# CITY PLANNING COMMISSION

- APPLICATION:
1. Variance to exceed 30% maximum number of compact car spaces by three spaces(6 permitted, 9 proposed) on 0.15 vacant acres
  2. Variance to reduce backout maneuvering distance for compact cars from 25 feet to 21½ feet

LOCATION: 816 and 820-29th Street

JEFFERY BUILDING RENOVATION - OFFICE CONVERSION

EXHIBIT A

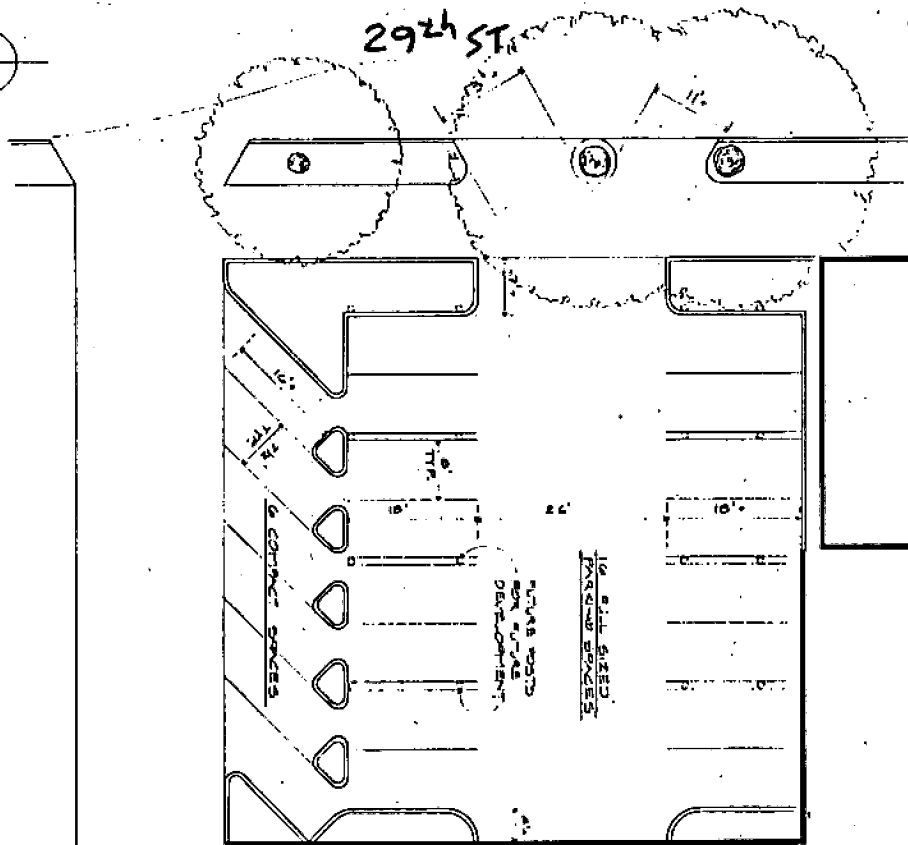
BACKGROUND INFORMATION: On February 11, 1982 the Commission approved a special permit to locate 12 required off-street parking spaces off site (on a vacant 80' x 80' lot on 29th Street, between H & I Streets) in conjunction with the conversion of the Jeffery Building (at southwest corner of 29th & I Streets) into offices. The applicant proposed a total of 22 spaces (12 required for Jeffery Building) to allow the future construction of an office building on the parking lot site (See Exhibit A).

The original plan proposed a split driveway permitting the preservation of a large Elm tree located in the public right-of-way along 29th Street. However, subsequent to the Commission approval, the Traffic Engineering Department requested a revision to the plan, indicating elimination of the split driveway with a conventional 90° driveway to 29th Street and removal of the Elm tree.

EXHIBIT B

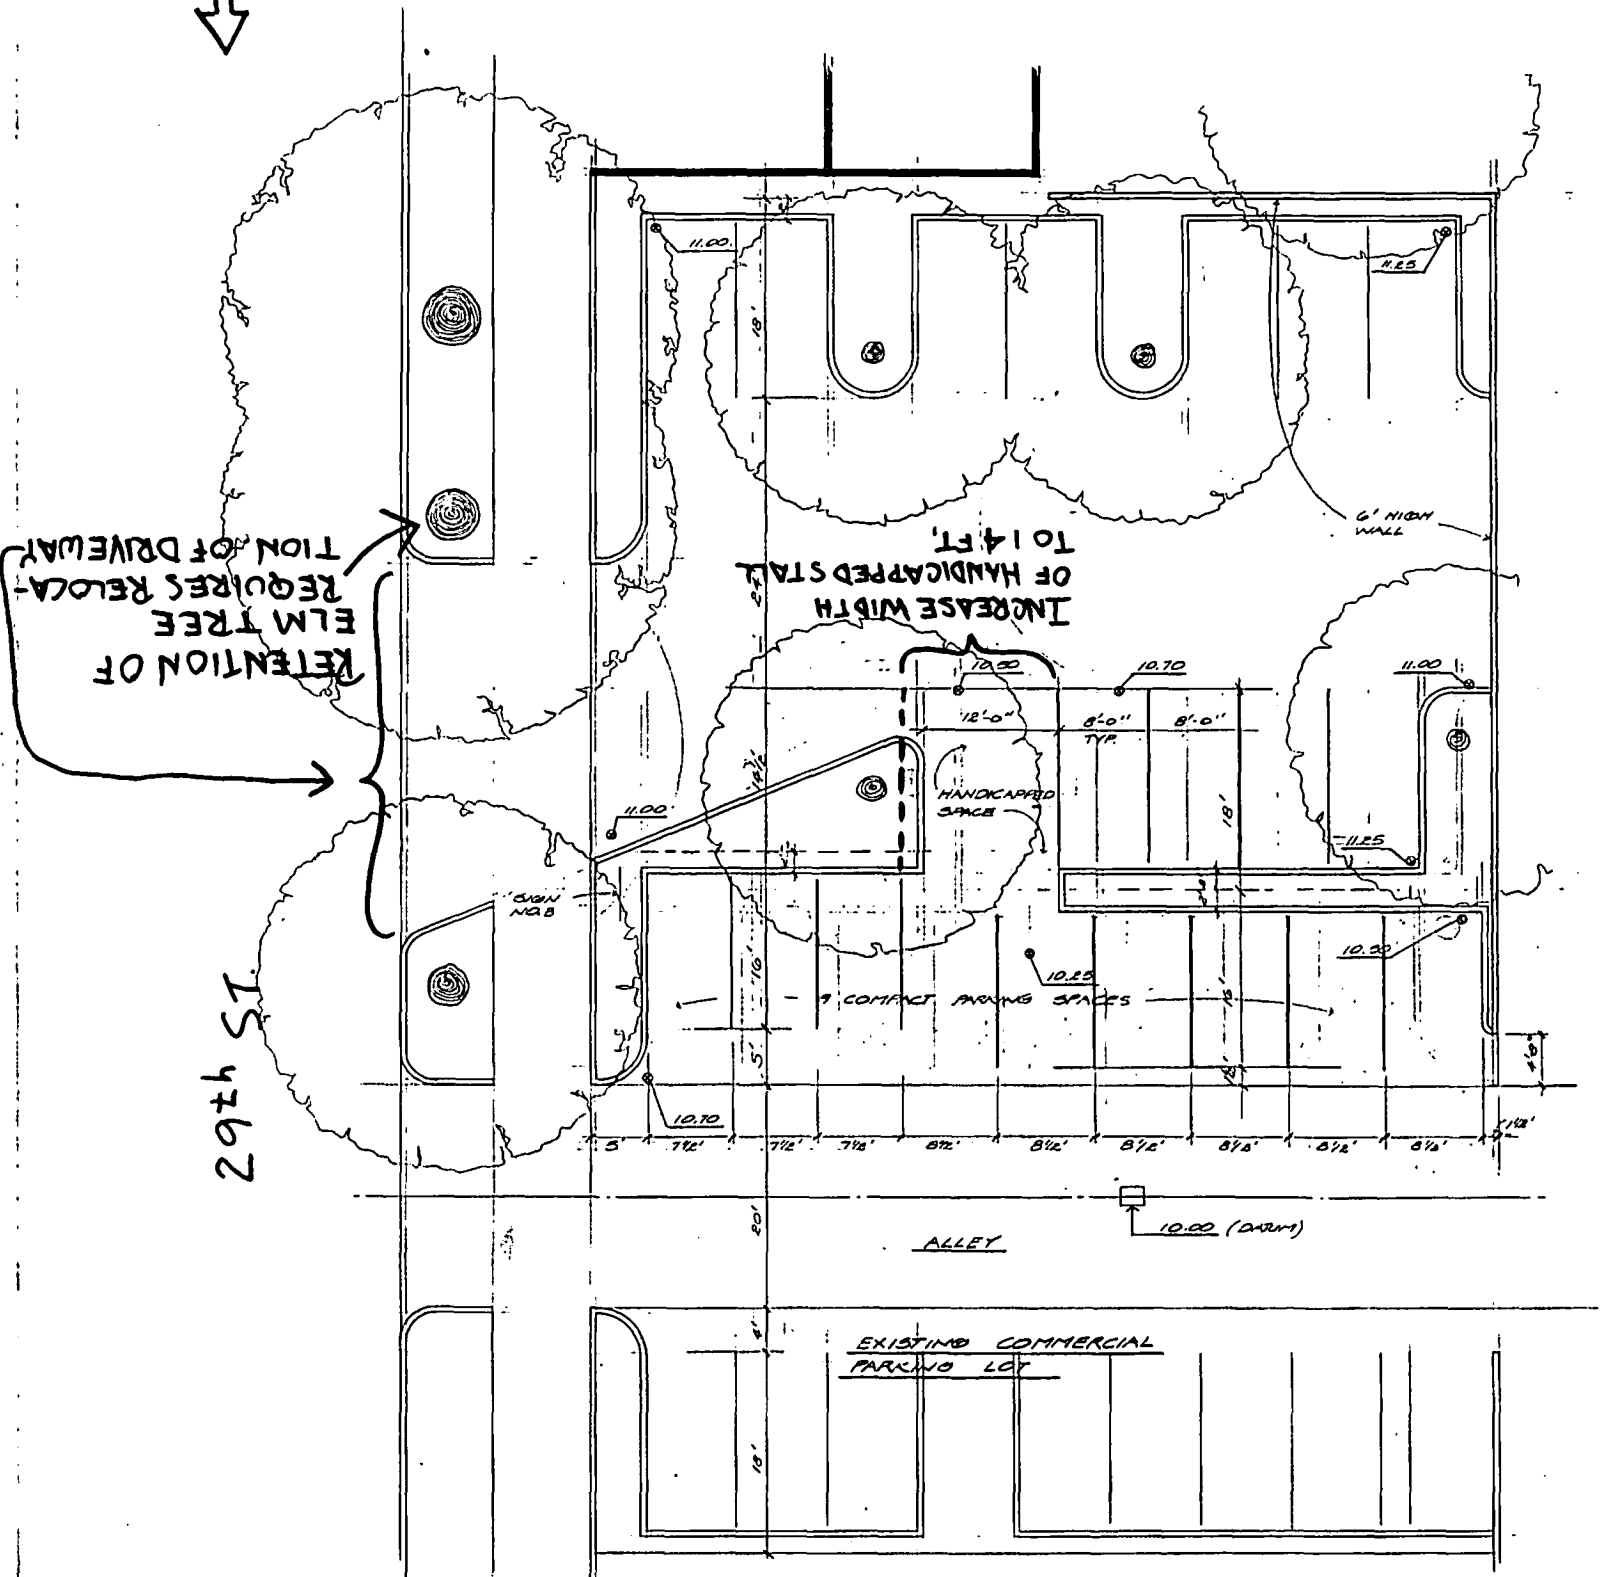
In order to preserve the Elm tree and comply with the Traffic Department concerns, the applicant is submitting a revised plan which involved shifting the driveway approximately 13± feet to the north (See Exhibit B).

1. The applicant is submitting a revised parking lot plan based upon the City Arborist's request to save a large, mature Elm tree (4½± ft. diameter, 80-100± ft. tall) located in the public right-of-way along 29th Street.

The revised plan (See Exhibit B) proposes a 21-space parking lot and shifts the driveway entrance approximately 13 feet to the north to accommodate the preservation of the Elm tree. The placement of the driveway requires the relocation of two parking stalls from the middle row to the northernmost row abutting the alley. In order to accommodate nine stalls along the alley, the 60° angle stalls are proposed as 90° angle. Due to insufficient distance and requirements to meet the 50 percent shading requirement, five of the nine stalls closest to the west property line abutting the alley have substandard backout maneuvering space (21½ feet vs 25 feet). In addition, the applicant has designated the five stalls as compact car spaces, thereby creating a total nine compact car spaces. The applicant, therefore, is requesting variances to reduce the backout maneuvering space for the five easternmost stalls by 3½ feet (21½ ft. vs 25 ft) and exceeding the 30 percent maximum number of compact car spaces by three spaces (6 permitted vs 9 proposed).

2. According to the City Arborist, the subject Elm tree is a healthy tree, approximately 4½ feet in diameter and 80 - 100± feet in height. If it is feasible to design a driveway around the subject tree, the Arborist recommends retention of the Elm. Staff concurs with the City Arborist and has no objections to the revised site plan and, therefore, supports the applicant's requests. Staff notes that a parking lot exists across the alley to the north, with approximately 4± feet of additional maneuvering space. Although technically, the 4± feet of maneuvering space is off site, from a practical standpoint, this area will also be usable by those parking on the subject site for backout maneuvering space.

- a. The applicant shall increase the width of handicap stalls from 12 feet to 14 feet per revised site plan (Exhibit B);
- b. The applicant shall designate the compact spaces on the pavement surface;
- c. The applicant shall submit a shading plan and detailed landscape and irrigation plan for the review and approval of the Planning Department prior to the issuance of an occupancy permit.
